ADDENDUM NO. 2
to
CONTRACT DOCUMENTS

for
ADDITIONS AND RENOVATIONS TO LITTLEBROOK ELEMENTARY SCHOOL
located at 39 Magnolia Lane, Princeton, NJ 08540

FVHD PROJECT NO. 5516D

Issued: March 24, 2026

Drawing Number
E3.1

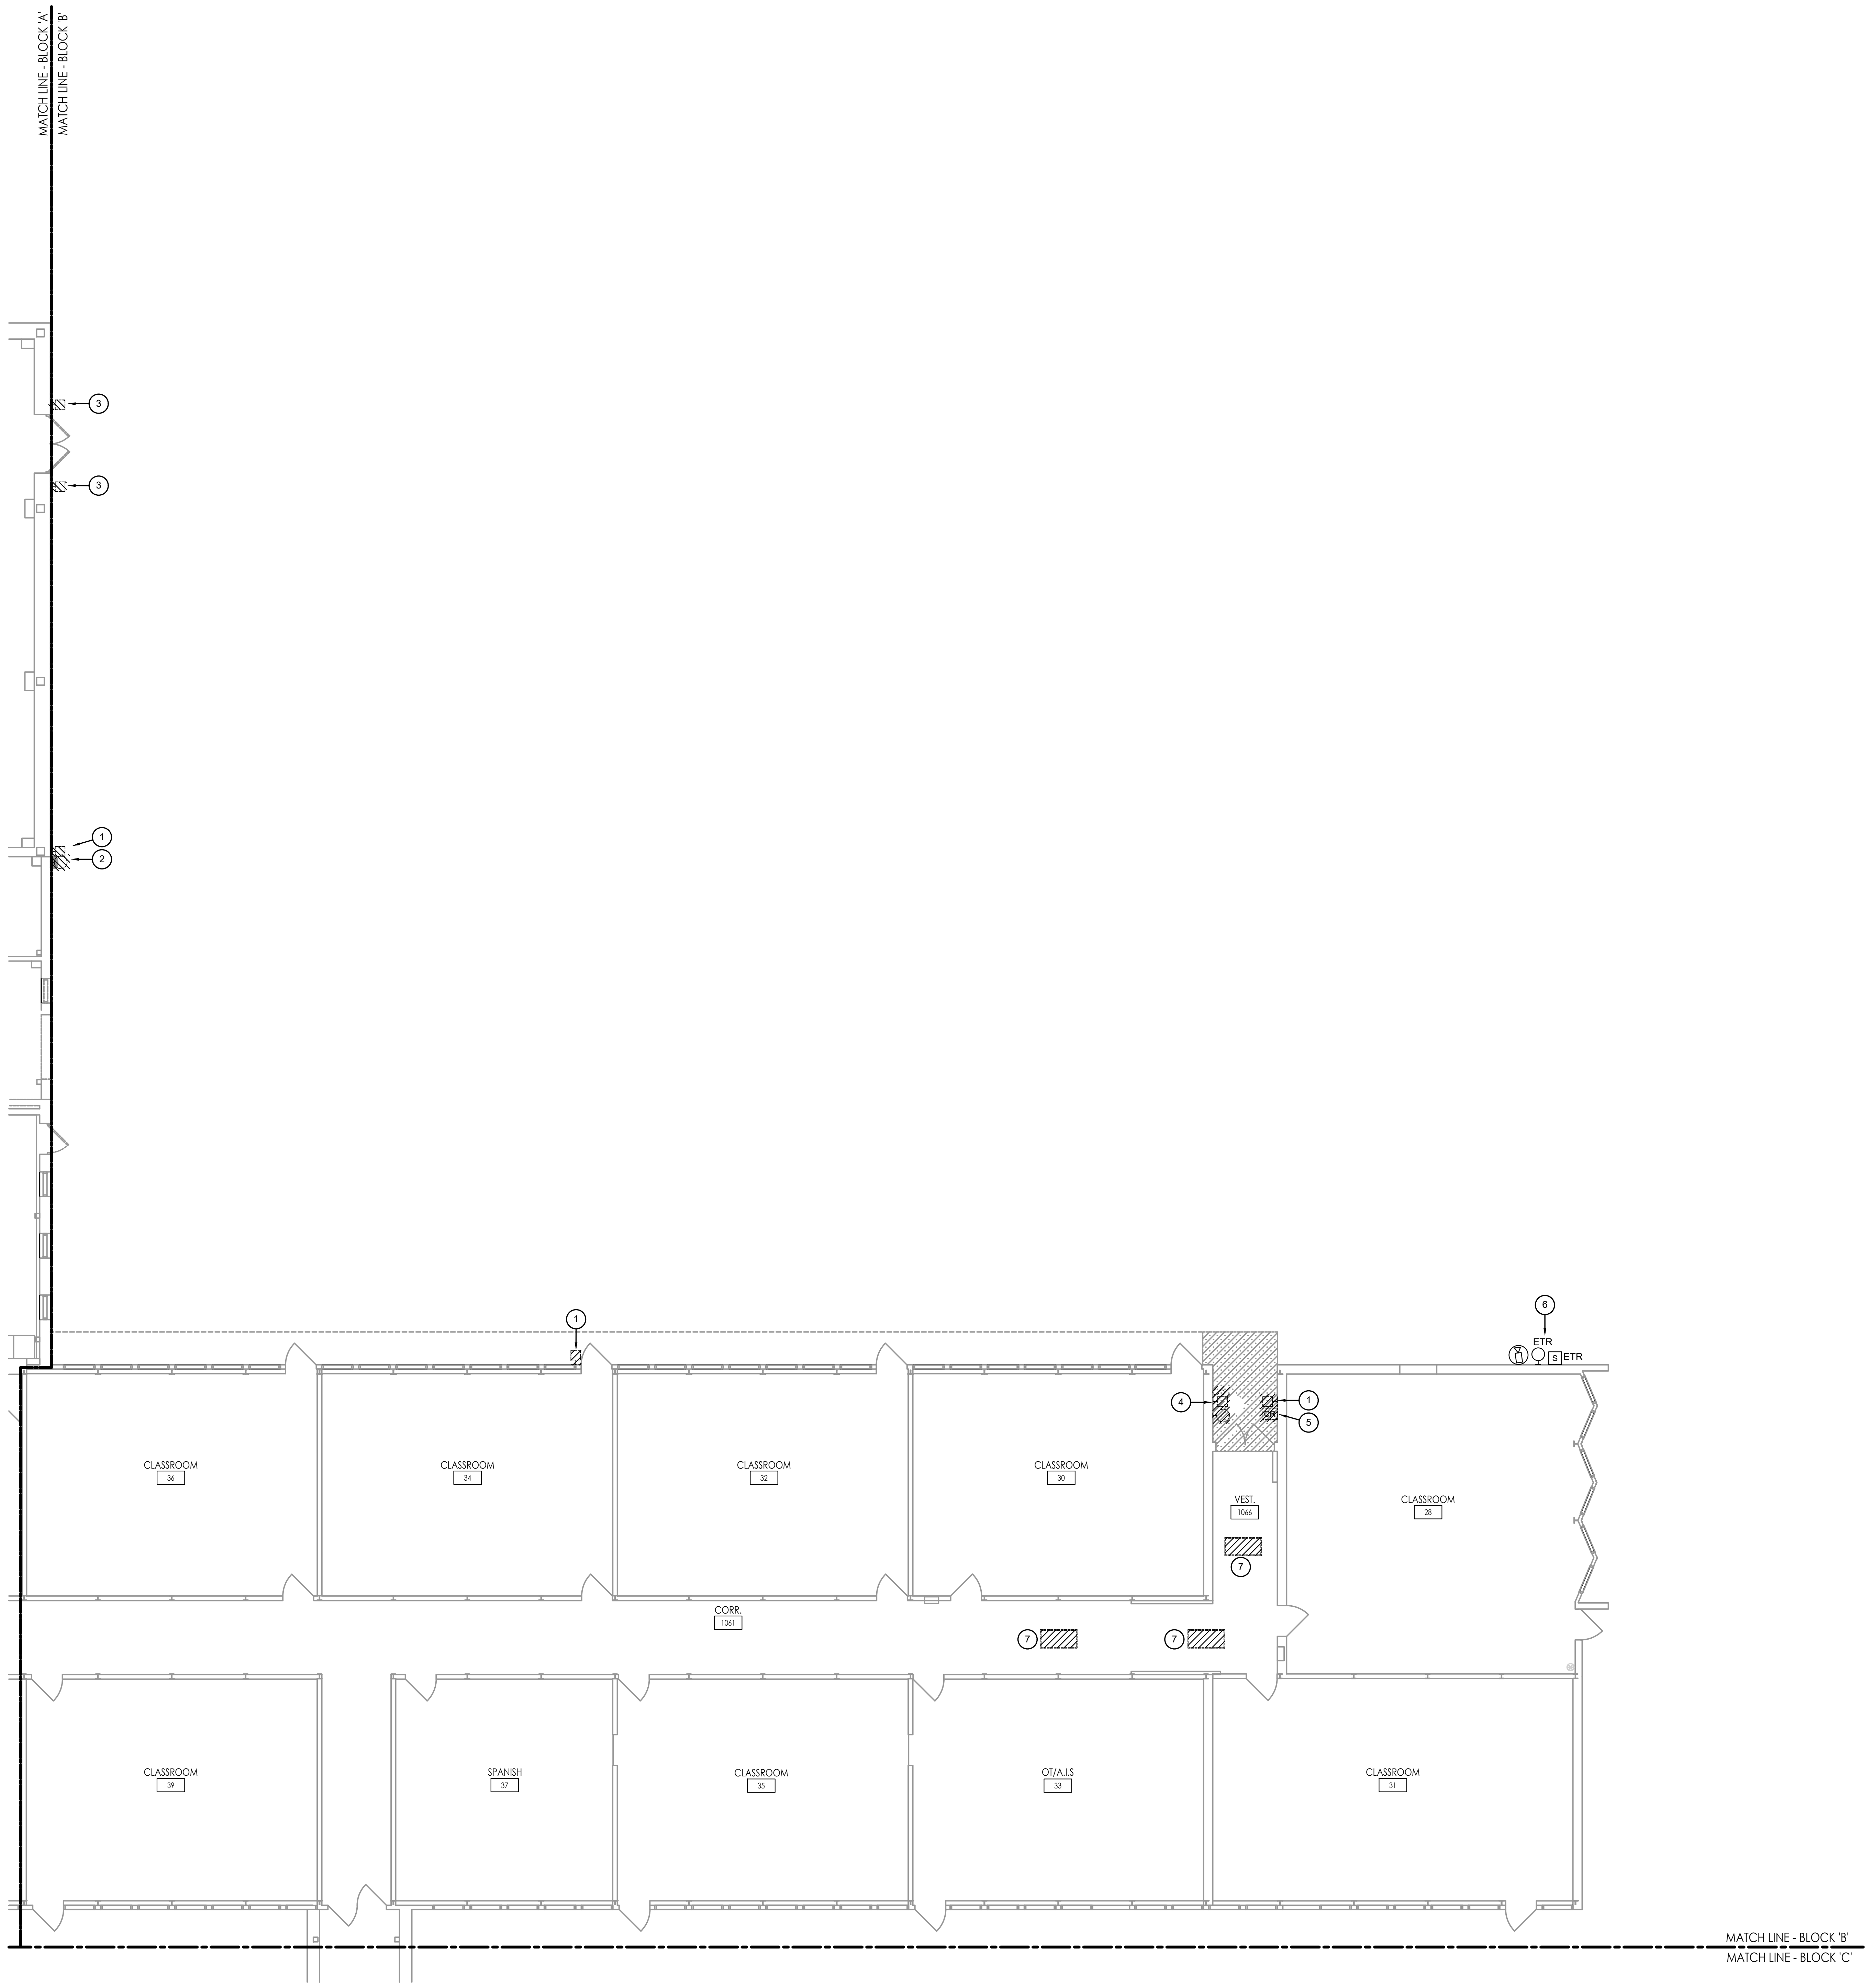
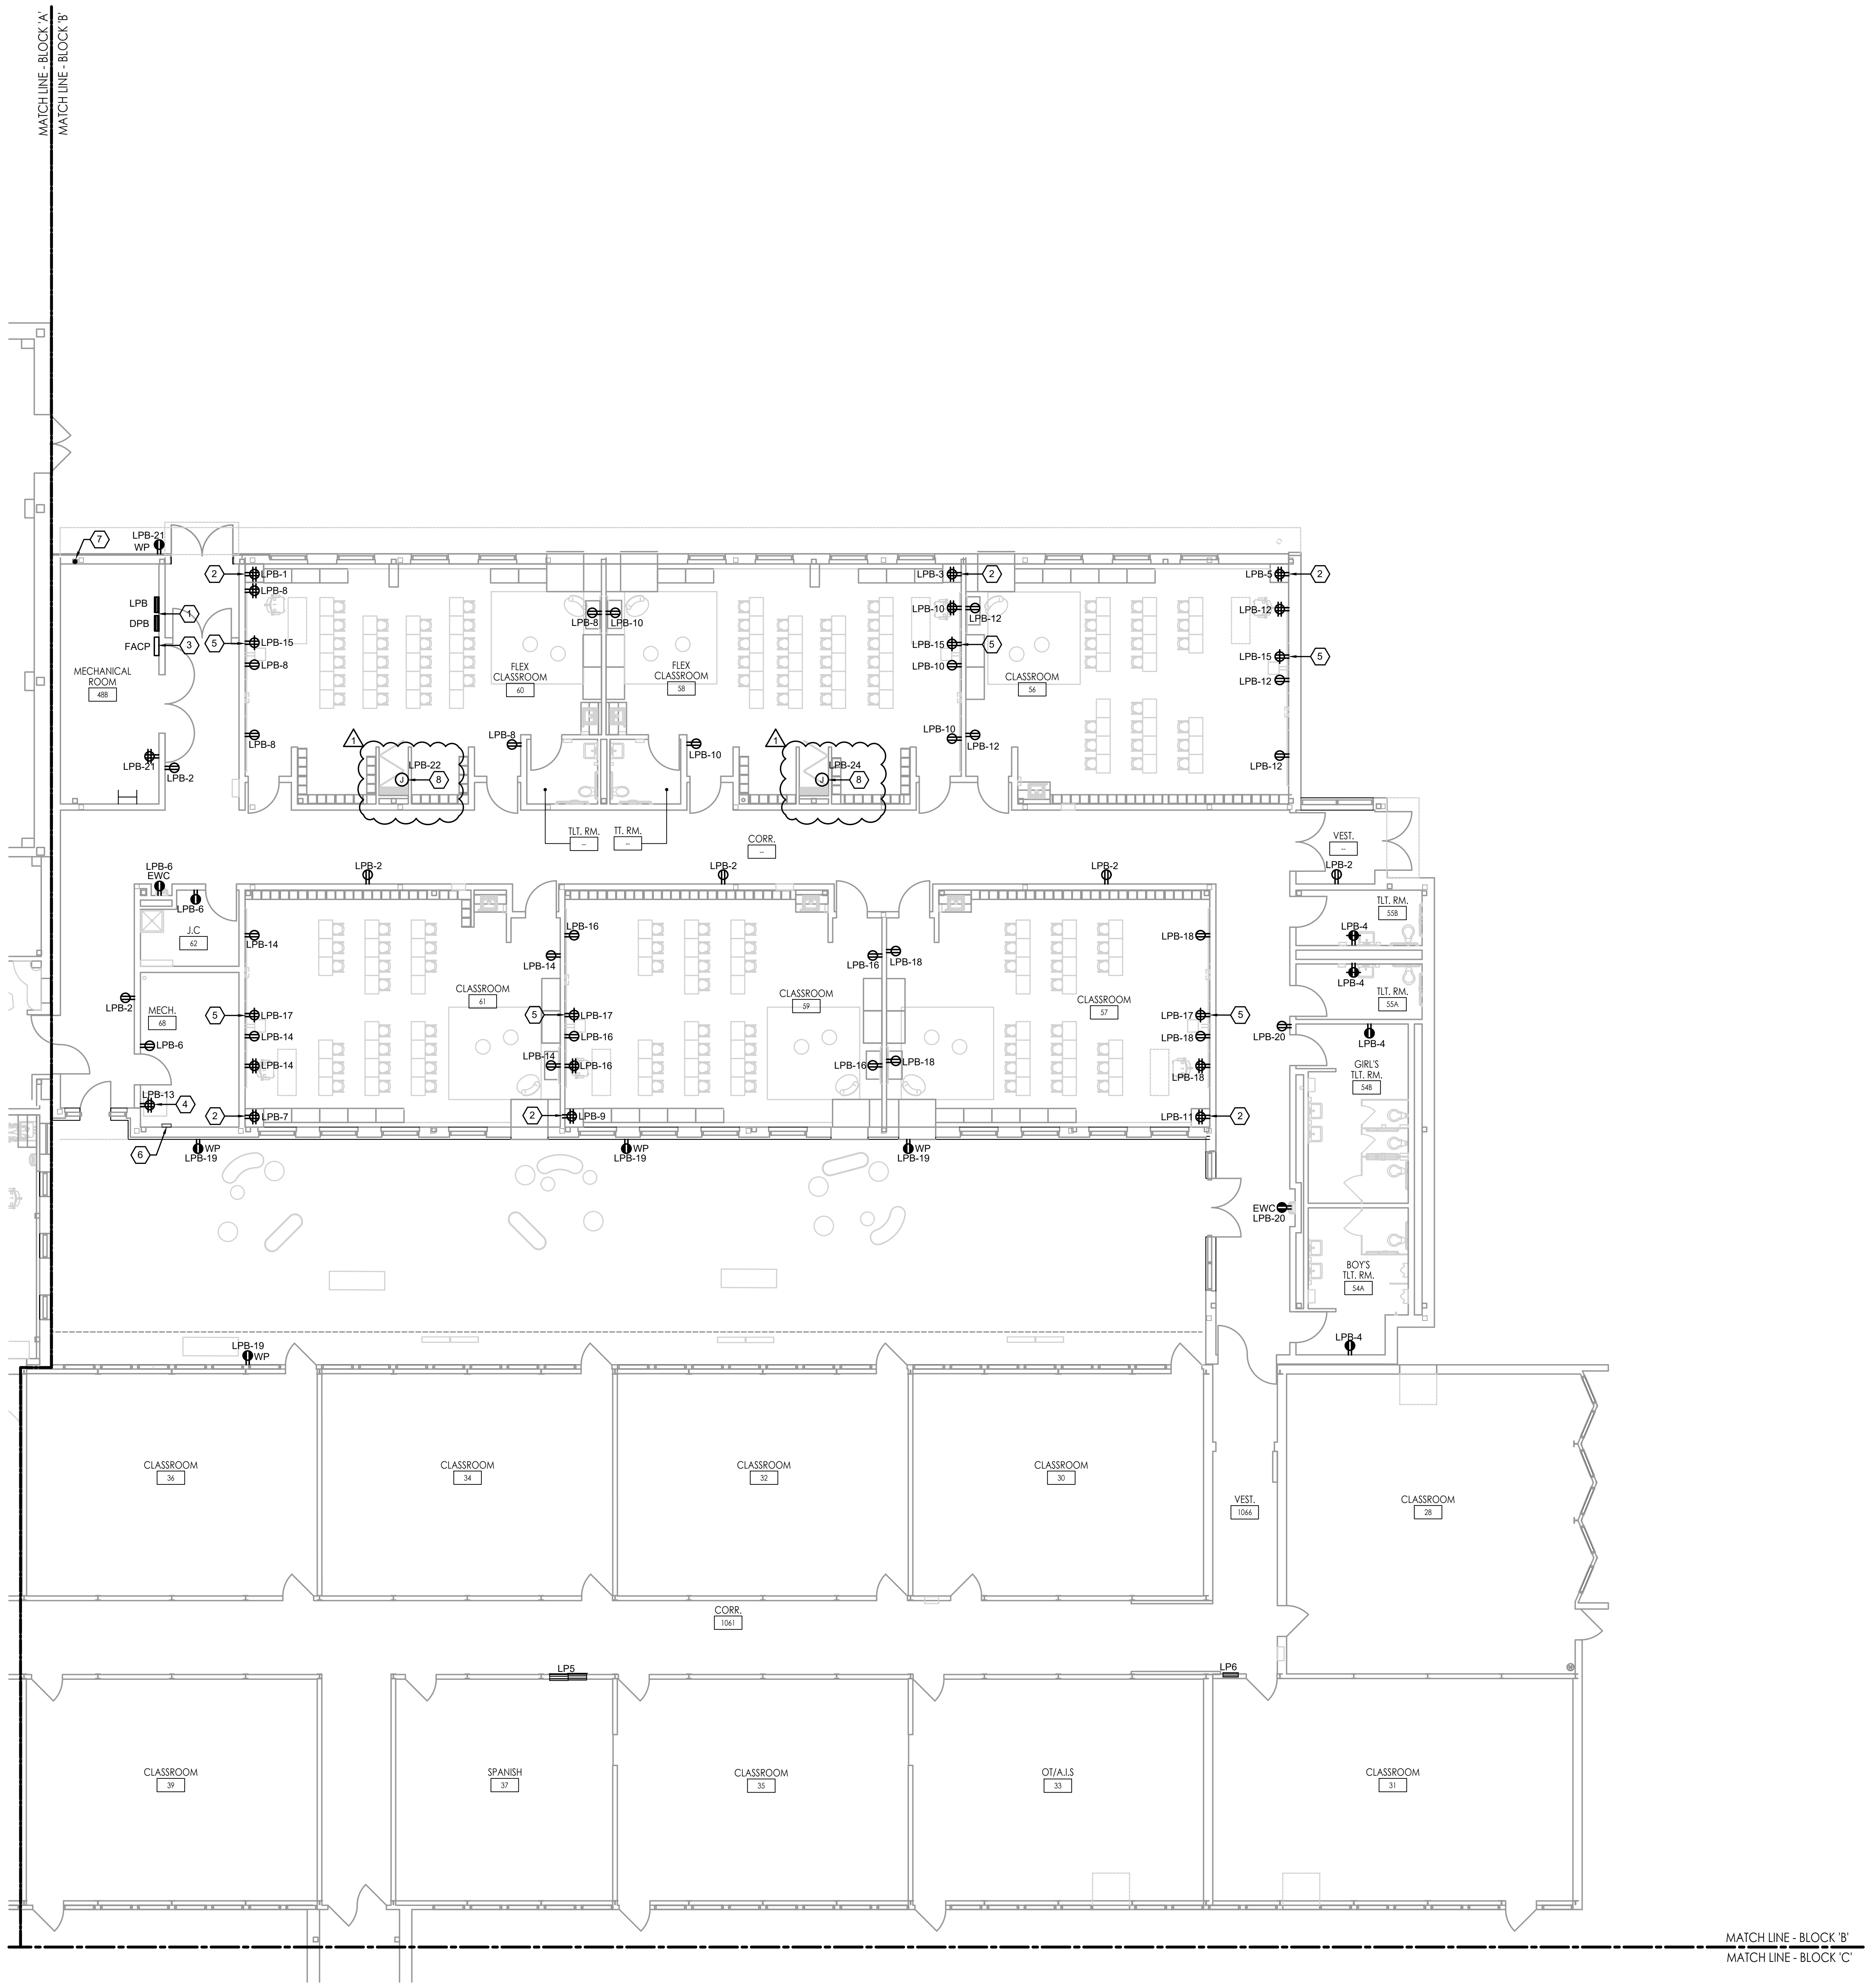
42. Question: In reviewing the Electrical Drawings specifically it appears E Drawings 3.1, 4.1, PART of 4.3, 5.1, 5.4, 6.1, 7.1, PARTS of 8.0, 9.0, 9.1 all have scope that should go with pricing for an alternate, yet none of these Drawings make any reference to that. This probably hold true with all MEPS Drawings. Please identify rooms and corresponding Alt #'s all work goes with so that all bidders and trades alike are able to provide accurate bids.
